SUBJECT: COMANCHE PEAK NUCLEAR POWER PLANT, UNITS 3 AND 4
DOCKET NUMBERS 52-034 AND 52-035
RESPONSE TO REQUEST FOR ADDITIONAL INFORMATION NO. 4957, 5027,
AND 5052

Response to Request for Additional Information No. 4957 (CP RAI #178)

Response to Request for Additional Information No. 5027 (CP RAI #177)

Response to Request for Additional Information No. 5052 (CP RAI #179)

Figure 1. Map of Quaternary geology, geologic field reconnaissance, and aerial photograph coverage of the site area and beyond.

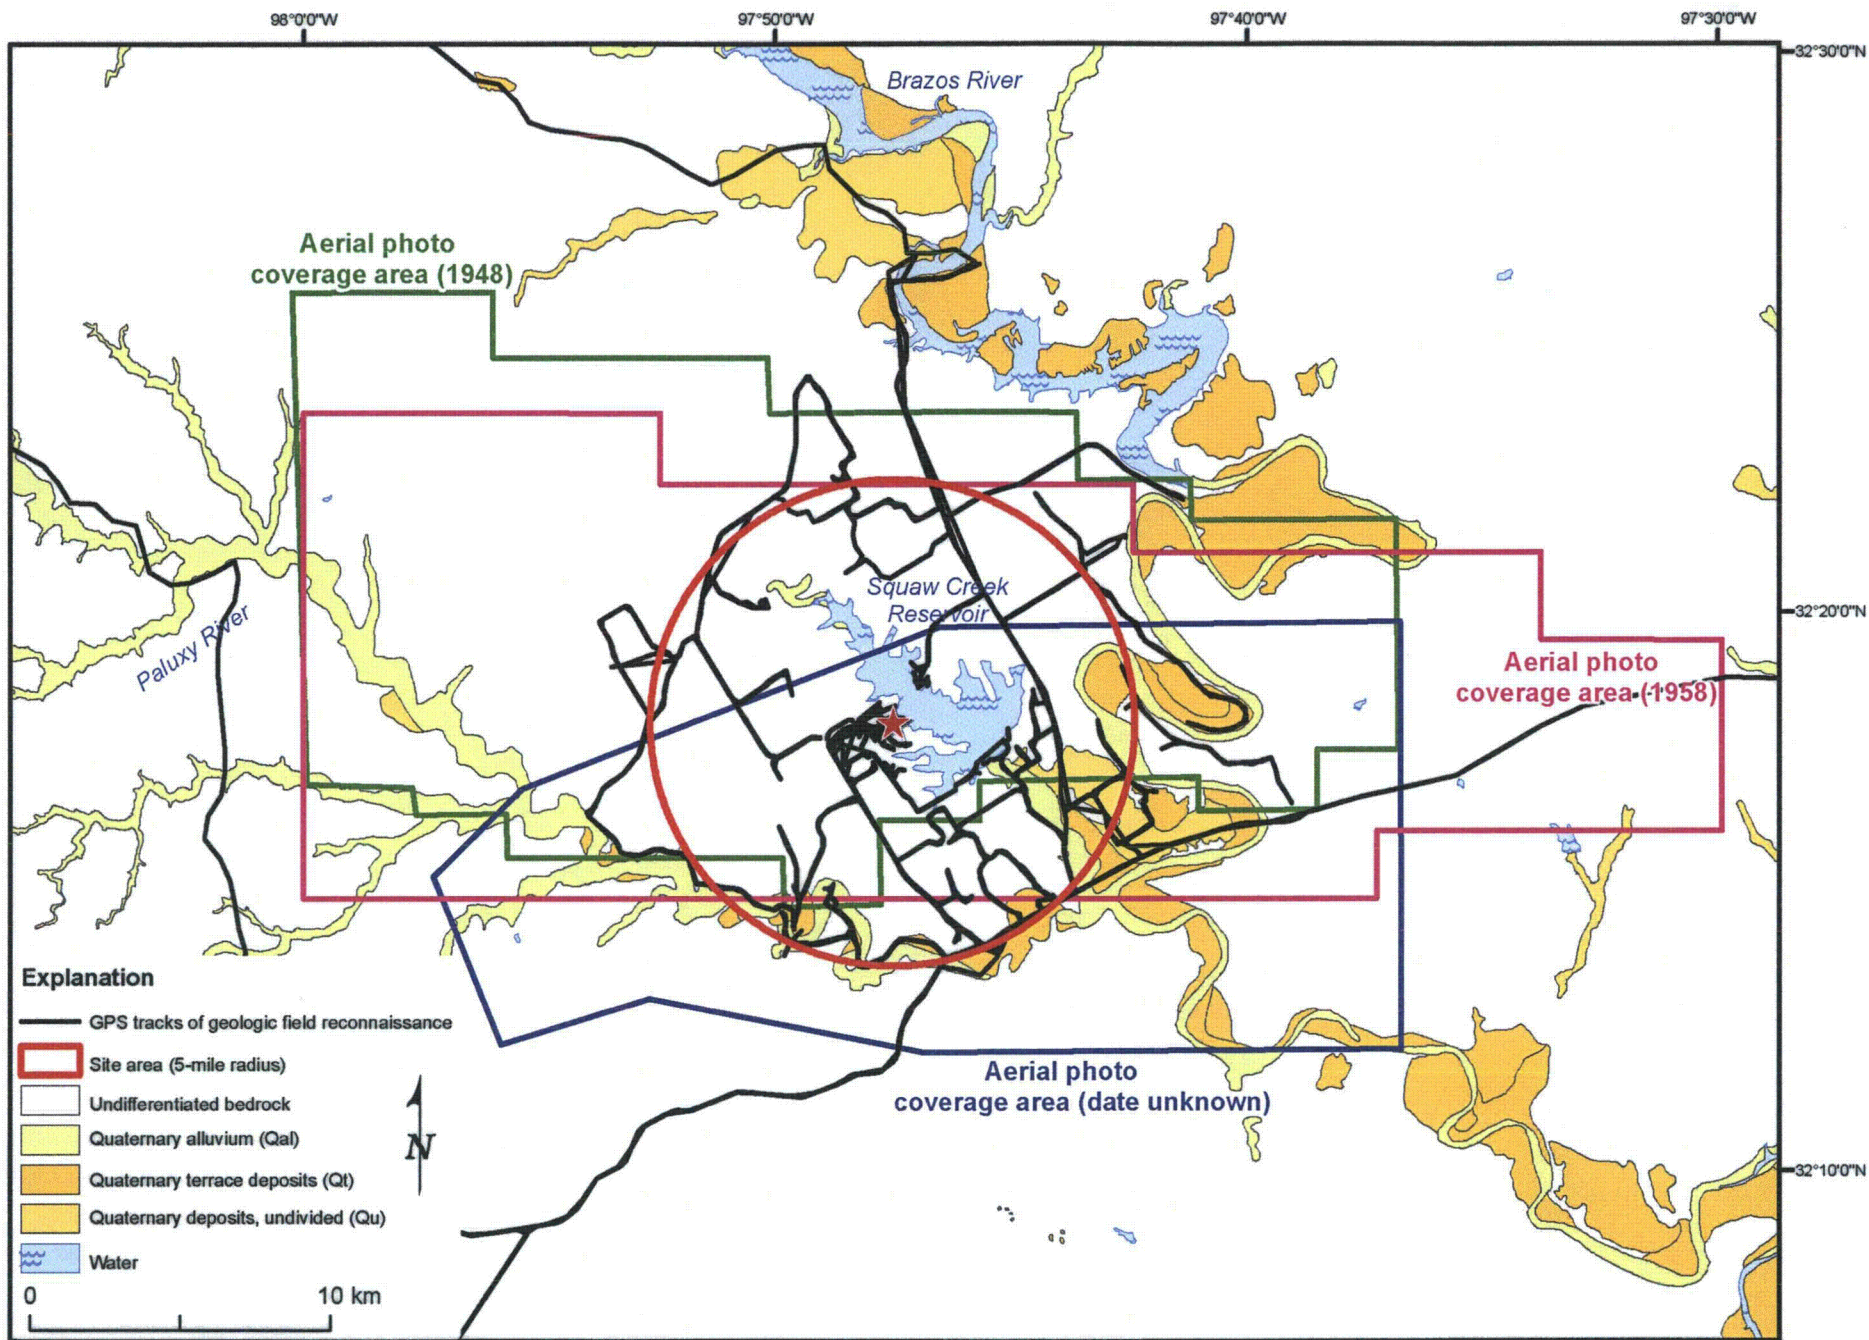
Please provide more detailed documentation of the locations investigated to specifically search for paleoliquefaction features or deformation in Quaternary alluvial deposits. Did you specifically search for locations, where outcrops of these deposits might exist? In addition, please explain if any follow up investigations were conducted to further investigate the presence or absence of such features.

(a) Did you re-investigate aerial photographs for signs of sand blows or fissures, separate from the lineament analysis? If not, why? (b) Did you re-investigate Quaternary alluvial surfaces when water levels and vegetative growth were at a minimum? If not, why?

The field reconnaissance records in the WLA "Field Reconnaissance Report" (ML092290416) do not specify any locations targeted for liquefaction inspection because no locations were identified from the initial evaluation of the aerial photography. As shown on the track log plots on Figure 1, the Quaternary deposits were visited where public access was available. No evidence for seismically-induced liquefaction was noted during geologic field reconnaissance. However, it was noted that much of the Quaternary surfaces are highly vegetated and exposures are limited. No follow-up investigations were conducted after the two site area reconnaissance visits.

(a) Aerial photographs were re-investigated to search for signs of sand blows and fissures. Figure 1 shows the coverage area of aerial photographs evaluated. As shown in the table below, these photographs are black-and-white images acquired by the U.S. Geological Survey (USGS) and Texas Natural Resources Information Services (TNRIS) between 1942 and 1958, predating construction activities at the site. These photographs include both stereo-paired and oblique imagery. A few of these photographs show semi-circular areas of light-colored surface material that could be interpreted as possible evidence for surficial sand-blow deposits. However, these features are located in areas of active cultivation as well as Glen Rose Formation outcroppings where the material is not susceptible to liquefaction (limestone and shale) and the water table is deep. Taken together, the results from geologic field reconnaissance and evaluation of aerial photographs indicate the absence of seismically-induced liquefaction features within the site area and beyond.

- (b) The Quaternary surfaces in the site area as shown on Figure 1 were not re-investigated due to observations made during the initial geologic field reconnaissance investigations and aerial photography review, neither of which provided evidence for seismically-induced liquefaction. Further, the sparse historical seismicity of the region does not indicate a strong potential for the existence of seismically-induced liquefaction features within the site area.
